Planning & Development Division
Planning & Economic Development Department
 Room 160
 411 West First Street
 Duluth, Minnesota 55802

File Number	PL 22-230	Contact	Jenn Moses, jmoses@duluthmn.gov
Type	Variance – Front yard setback	Planning Commission Date	January 10, 2023
Deadline for Action	Application Date	December 16, 2022	60 Days February 14, 2023
	Date Extension Letter Mailed	December 21, 2022	120 Days April 14, 2023
Location of Subject	110 W Redwing Street		
Applicant	Many Rivers Montessori	Contact	Nicholas O'Connell
Agent	Arola Architecture	Contact	Ryan Arola
Legal Description	010-4670-00930		
Site Visit Date	January 3, 2023	Sign Notice Date	December 27, 2022
Neighbor Letter Date	December 20, 2022	Number of Letters Sent	54

Proposal:

The applicant is seeking to construct a three-story indoor/outdoor classroom addition with a footprint of 1,542 sq ft. This addition would be partially within the 25' front yard setback.

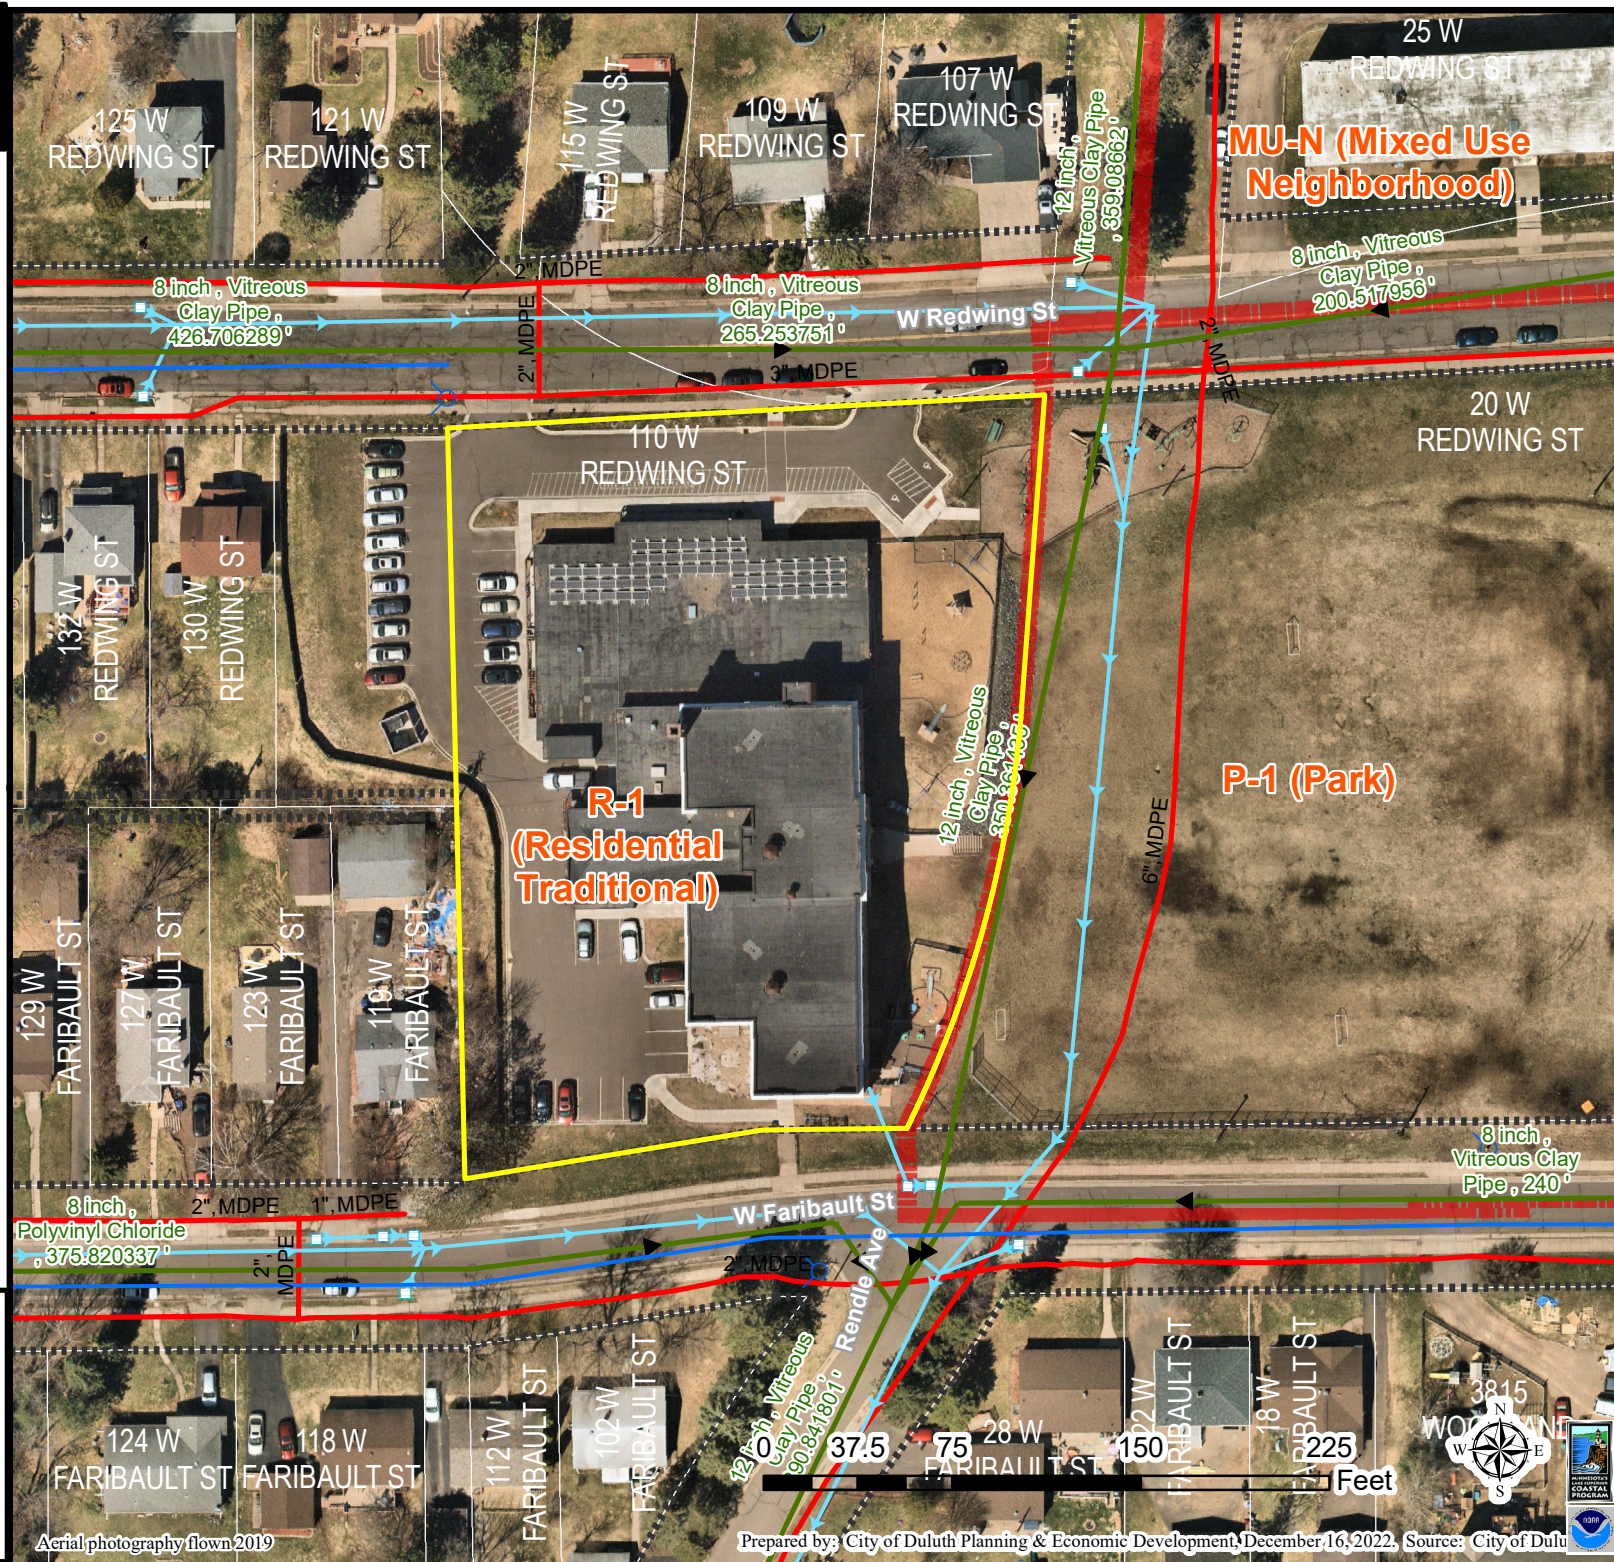
- 1) The existing building has an address on Redwing Street, but--as the zoning code stipulates that the narrowest dimension on a public street shall be the lot front--the front yard setback of 25' applies along Faribault Street. The existing building is approximately 12' from the property line on Faribault Street.

- 4) The applicant is proposing this addition to the southwest of the existing building, as other possible locations would disrupt the school's parking, loading/drop-off, and interior circulation. The addition infills a recessed corner of the building and would encroach no closer to the street than the existing school façade. Because the property line veers south towards the western portion of the lot, the addition would be 14' 9" from the property line on the eastern corner, where it ties into the existing school, and 22' from the property line at the western corner of the addition.

A2.0

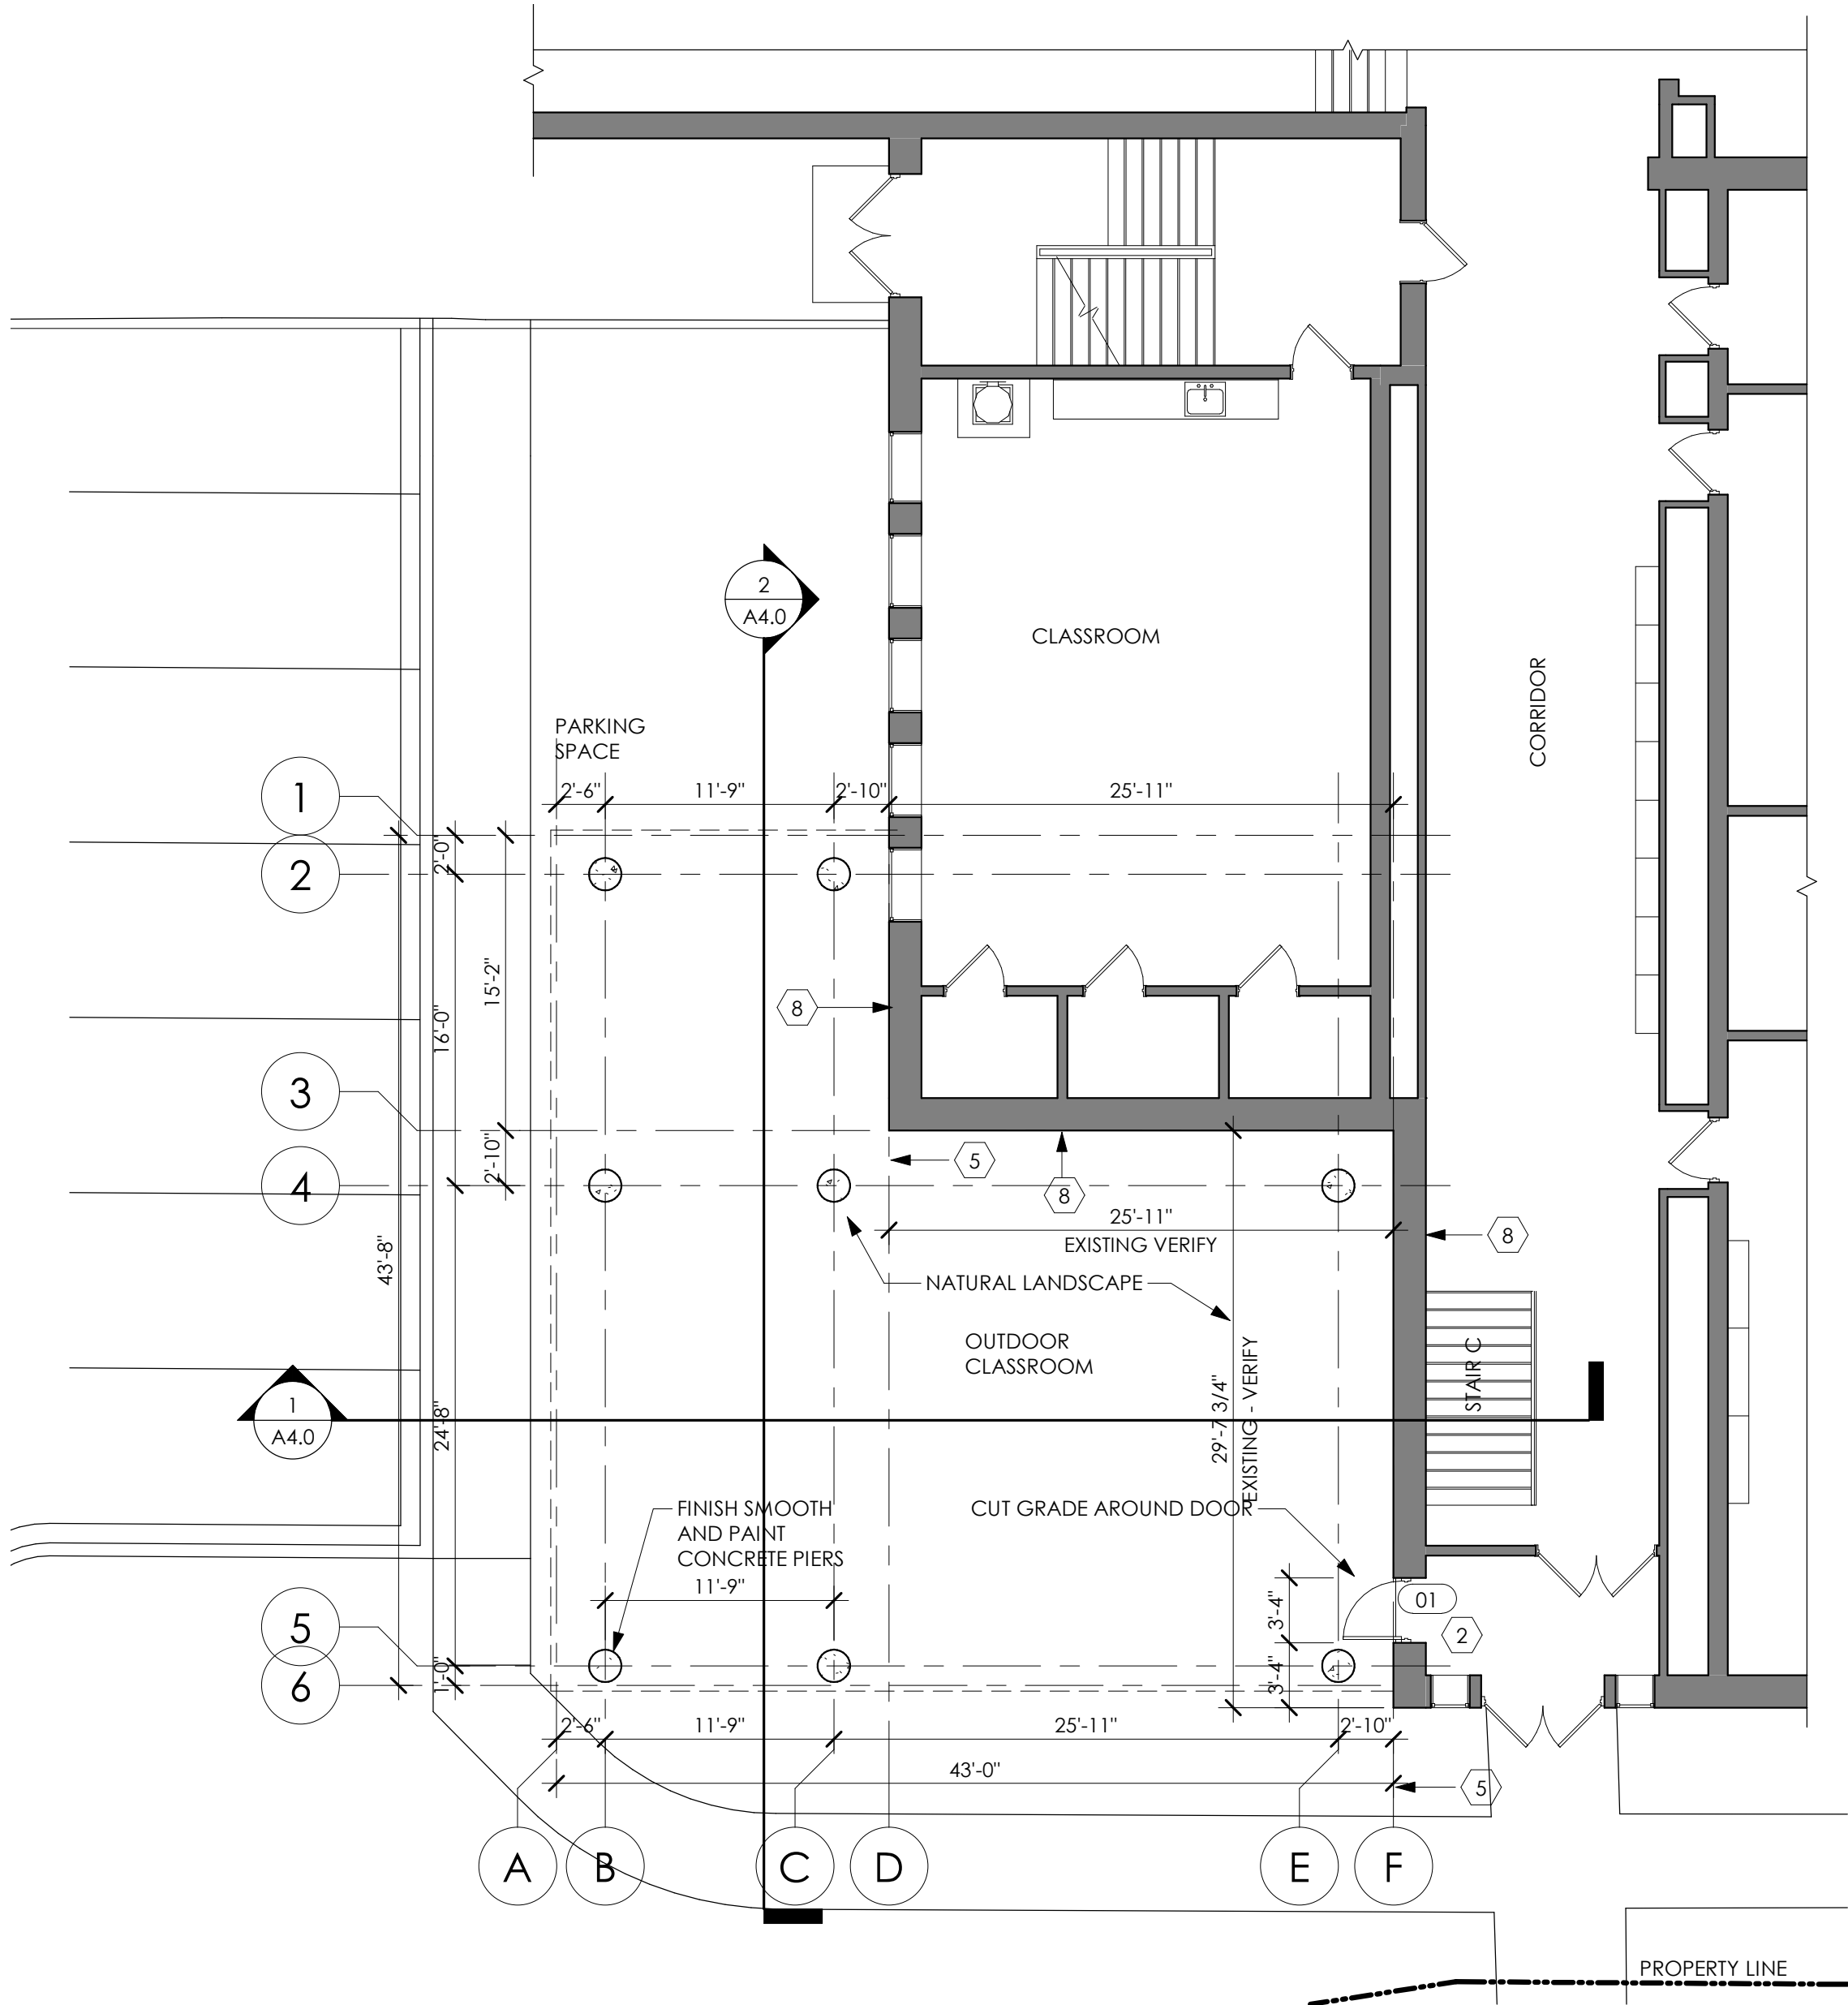
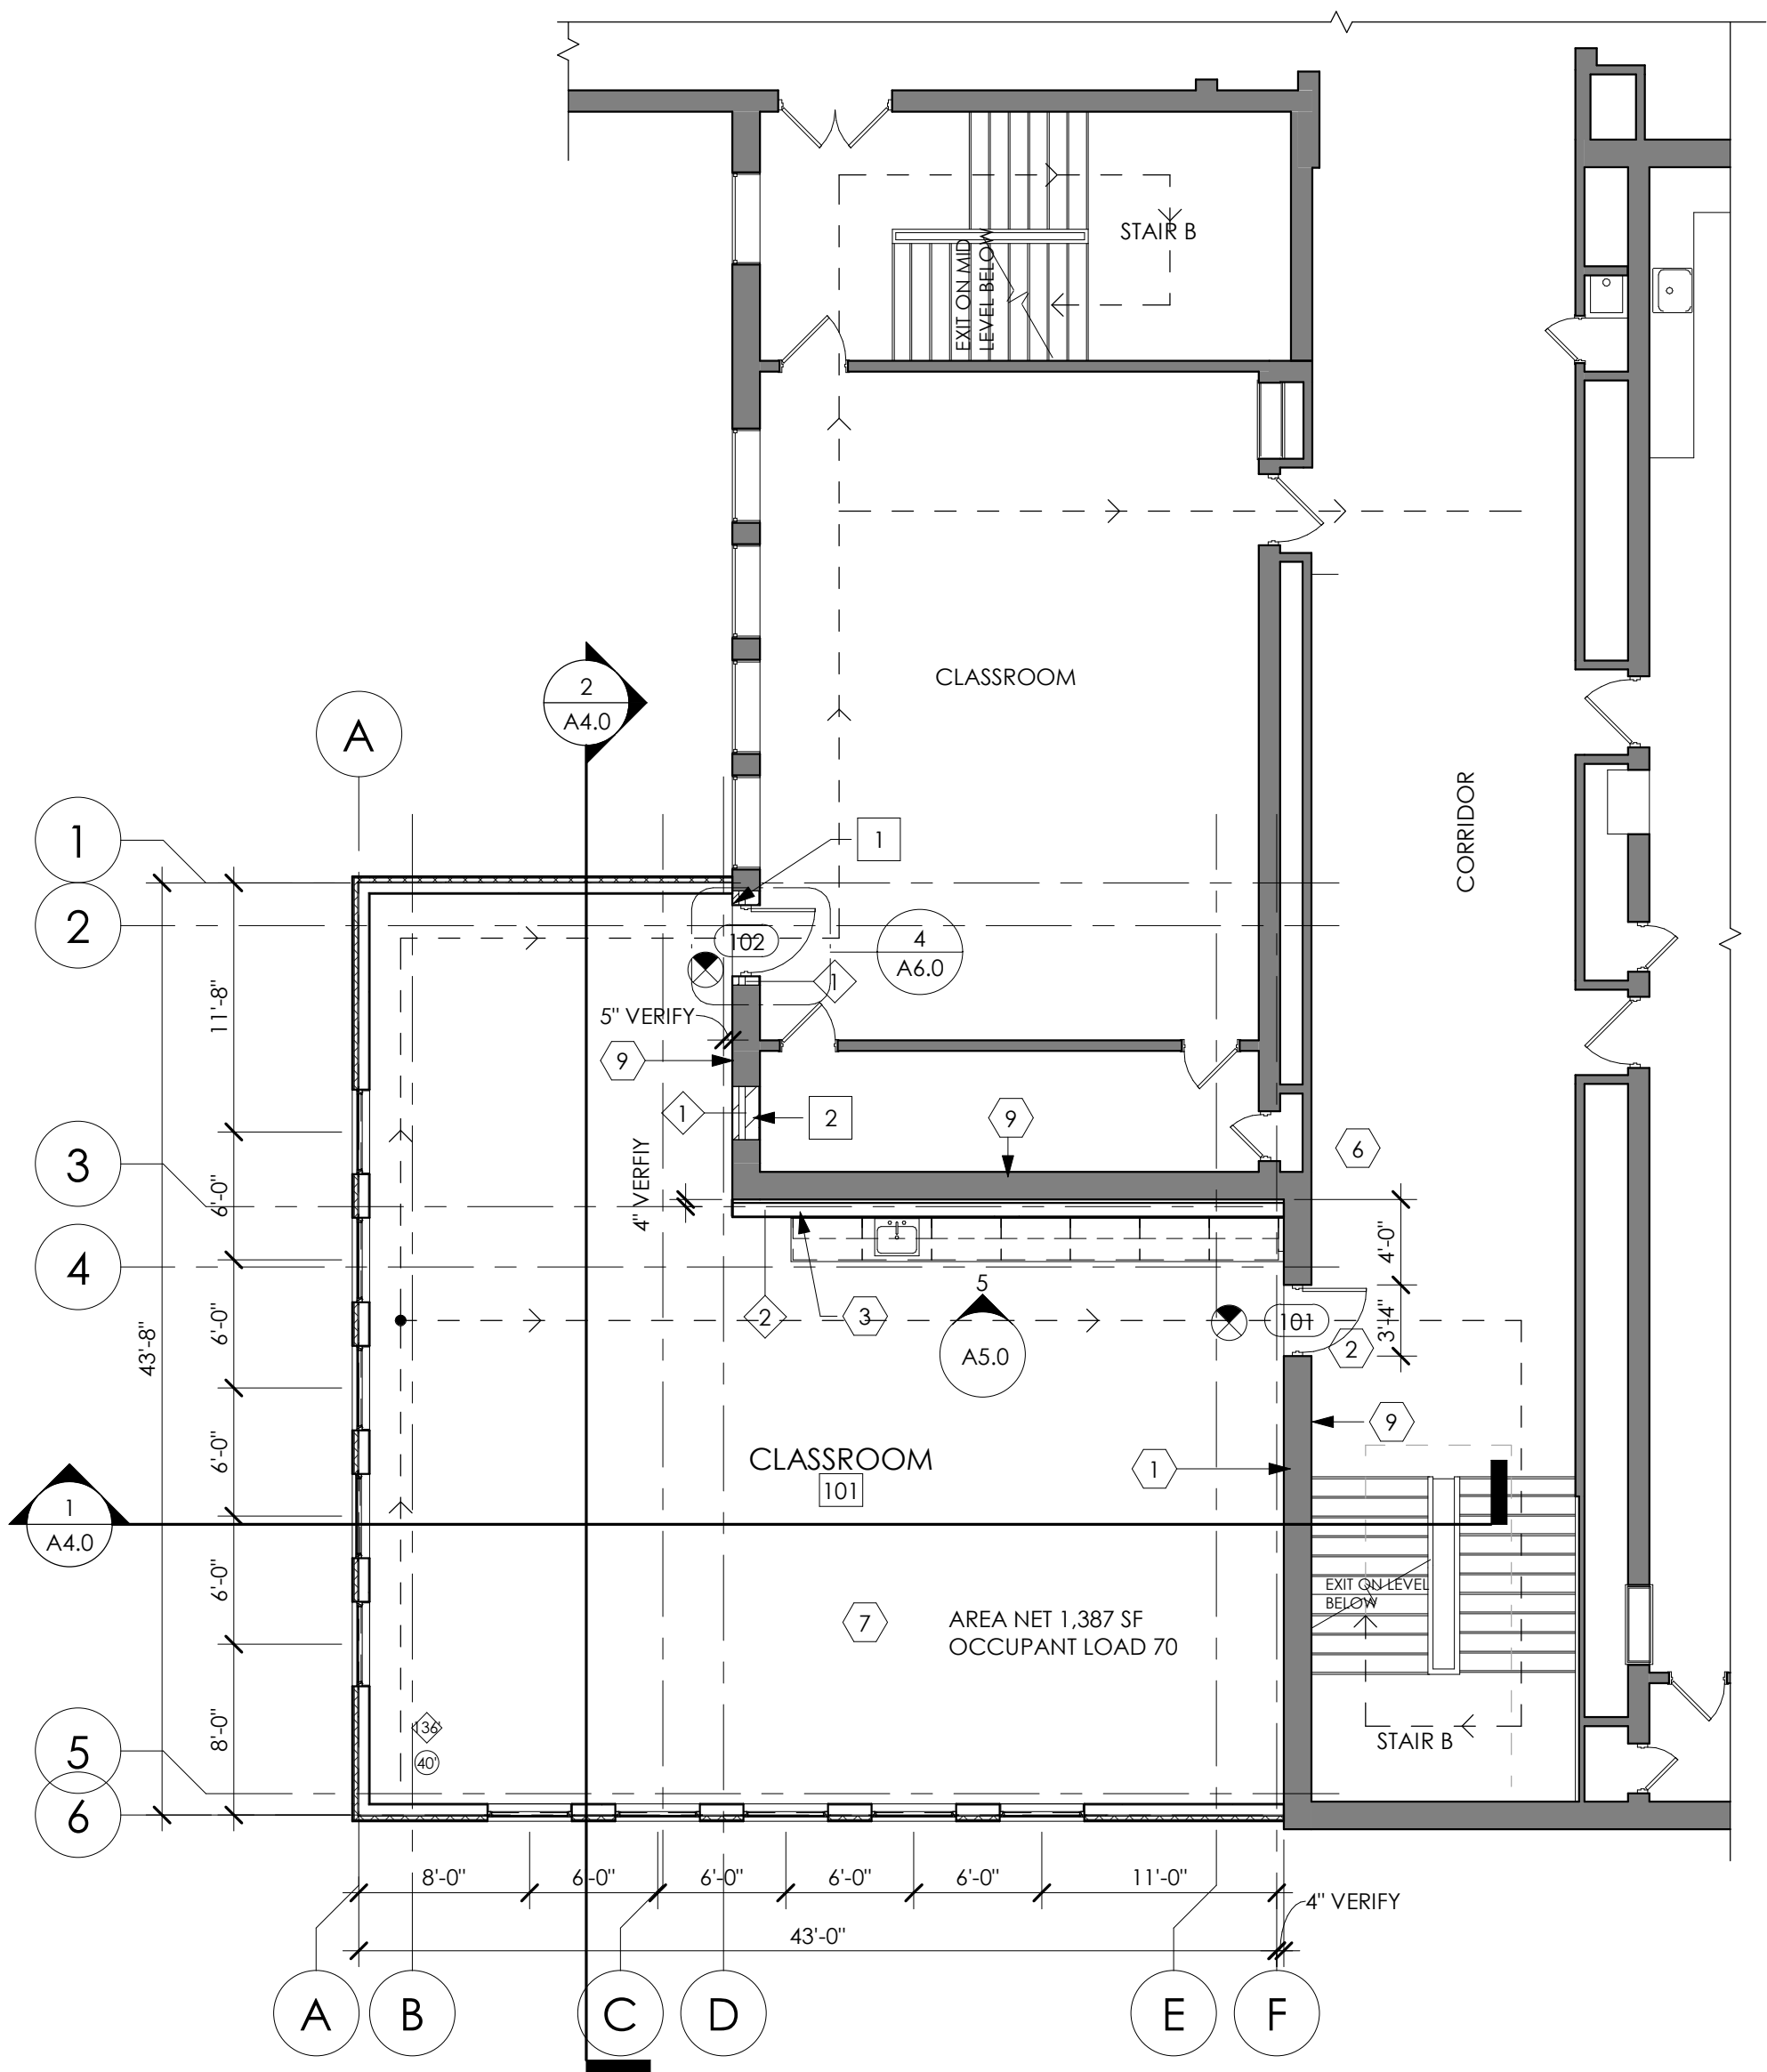
- 1) The project be limited to, constructed, and maintained based on the proposed plan attached to this staff report.
- 2) The plans submitted for the building permit application shall include height calculations for the addition and pergola to demonstrate compliance with the height maximum in the R-1 district.
- 3) Applicant shall provide financial security covering the cost of landscaping approved in 2017 prior to the initiation of any site work; this financial security shall be held, without interest, until the applicant has 1) installed the required landscaping, 2) hired a certified landscape architect to inspect landscaping and confirm that all landscaping was installed correctly and according to approved plans, and 3) forwarded inspection results to the City along with a request for reimbursement of this security. Prior to receiving a Certificate of Occupancy, the applicant shall
